## **CABINET MEMBER FOR ENVIRONMENT – 12 SEPTEMBER 2019**

### **BANBURY - BLOXHAM: A361 BANBURY ROAD – PROPOSED SHARED USE CYCLE TRACK**

**Report by Director of Community Operations, Communities**

**A361 Shared Footway Traffic Regulation Order (Sheet 1 of 3)**

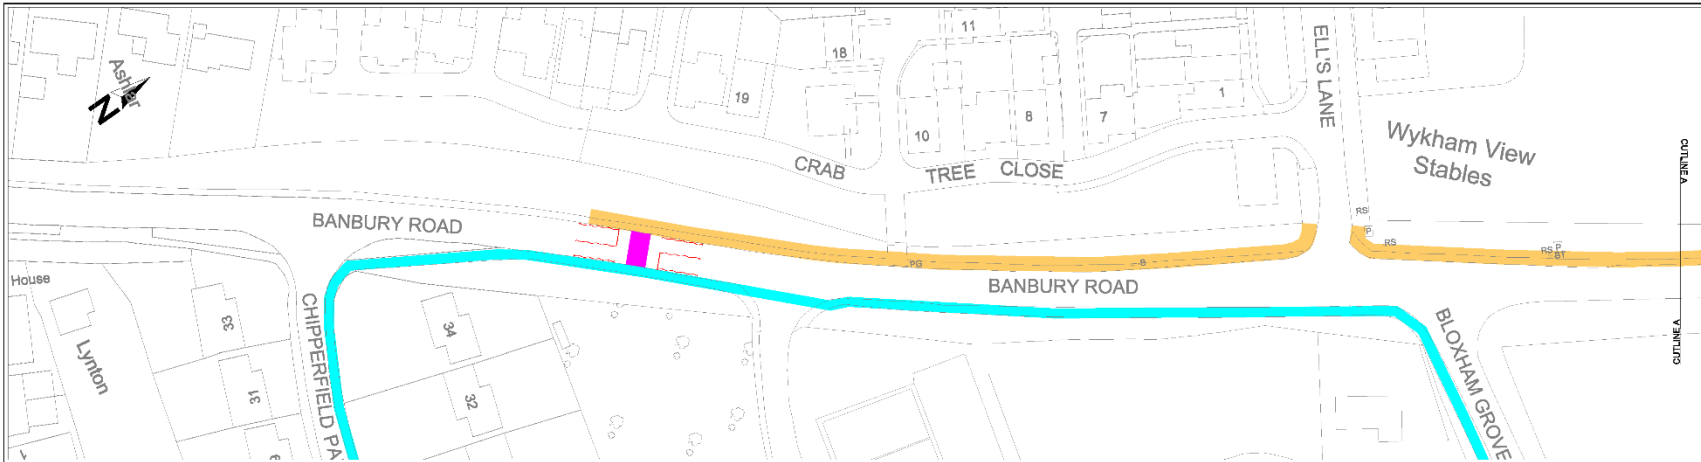
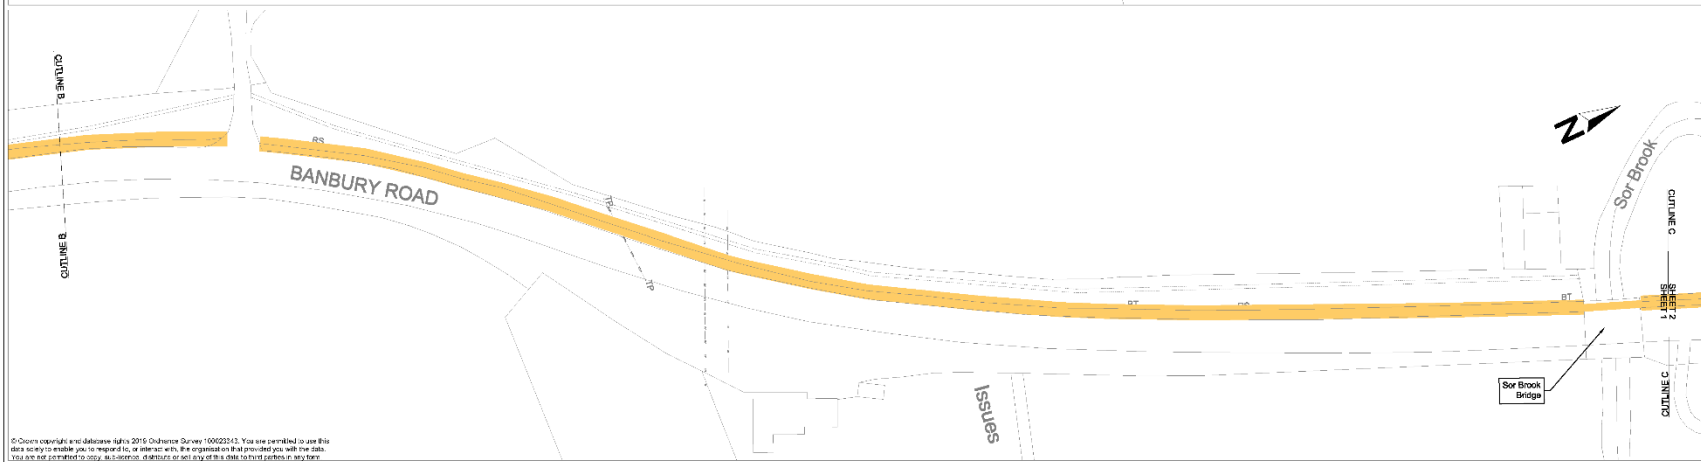
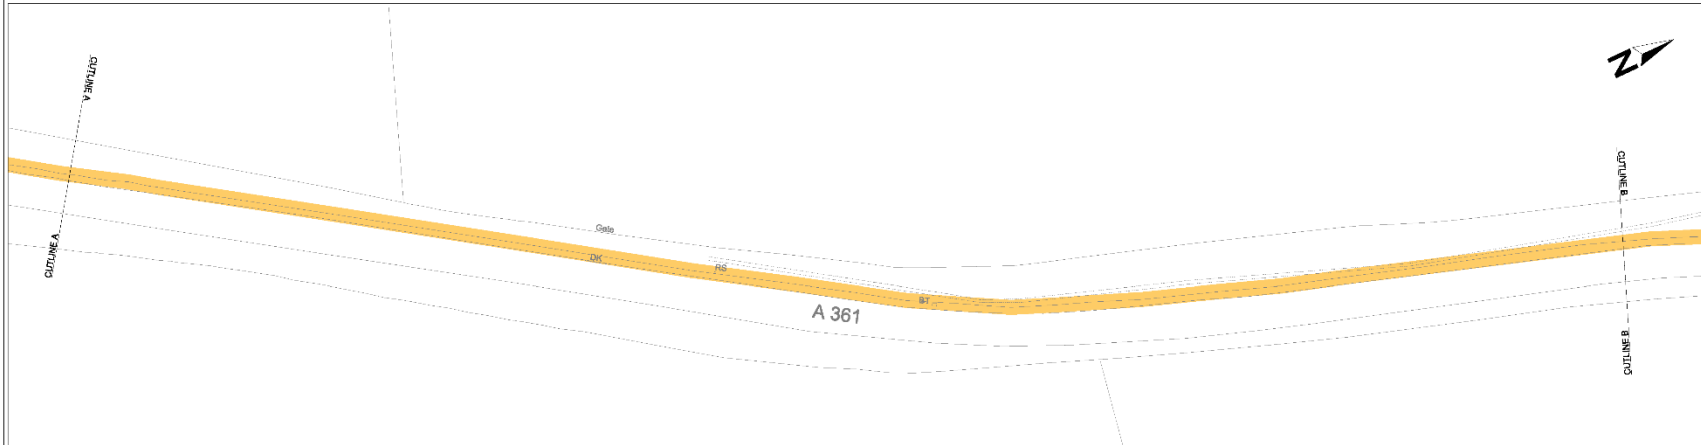
Our main comment on the proposals is on the ‘green’ section. We object to the 1.2m width proposed for this section because we do not understand why this inadequate width is necessary when the rest of the scheme (and the plans to the North) is much better specified. To illustrate the difficulty of this width, one of my bikes has handlebars 760mm wide.

The entry to Vantage Business Park looks dangerous for cyclists heading north if they are not seen by motorists heading north and entering the business park. It is not easy for cyclists to look directly behind themselves. The track needs to pull in earlier, so it arrives at the junction more parallel, and/or the road needs a tighter entry radius, and/or a warning sign. Is the island wide enough for a reference cycle design vehicle (2.8m)?

(7) Local Resident, (Bloxham)	<p><b>Support</b> – the proposal has my full support. I think it is an excellent plan.</p>
(8) Local Resident, (Banbury)	<p><b>Support</b> – While the proposals are supported there is a potential safety issue immediately outside 2 Crouch Cottages where there is a vehicular access for the property directly onto the Bloxham Road. If the proposal is to widen the cycle path from Bloxham up to the northern edge of the cottages there is a likelihood of increased cycle speed across the vehicular access especially given the vegetation growth that already obscures views along the road. Is it possible to reduce the width of the cycle access at the southern border of the cottages rather than the northern one (where the proposal is to retain the narrow footpath because of the existing ditch) or at least put some warning sign on the cycle path ("Give Way" or "Stop") or speed mitigation (rumble strips) for cyclists?</p>

11. Noting the above response, the reduced width of the proposed shared use track north of Crouch Cottages is acknowledged as substandard but it is anticipated that planned development will provide in the reasonably near future a track of standard (3 metre) width. Given this, it seems appropriate to accept as a short-term measure converting the existing 1.2m width footway to shared use, rather than the alternative of having a gap in the cycle provision.

12. The comments on the detailed design of the junctions – including whether priority is given to cyclists – will be reviewed as part of the detailed design. It is, however, not considered viable taking account of the budget and highway space available to provide a verge between the carriageway and cycle track. The comments on the quality of the surfacing and its ongoing maintenance are noted.

13. Expressions of support were received from three members of the public including a resident of Crouch Cottages, who though expressed a concern that the detailing of the layout (including traffic signs and markings) of the cycle track at the vehicle access to the property made provision for vehicles to enter and leave the access safely. It is confirmed that this will be checked and assessed as part of the detailed design.
